**RE: College Place Elementary and Middle School Replacement (PDR-25-0005) –
Second Review Comments**

PDR Plan Set Part 2 Landscape Plan Sheets L2.00-L2.07:

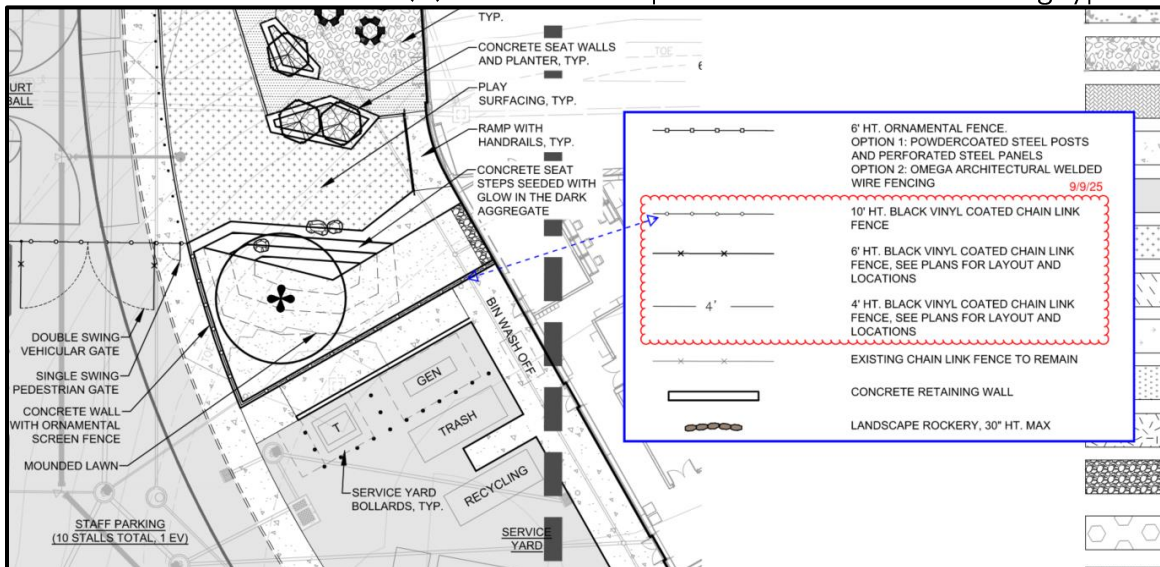
- ☐ **CORRECTION:** L1.04 Fencing NE of dropoff loop shows circle symbology which is called out as 10' black vinyl chain link fence, not 6' ornamental fencing. Correction response letter indicates that this should be the 6' fencing. Please ensure plan set shows correct fencing type.
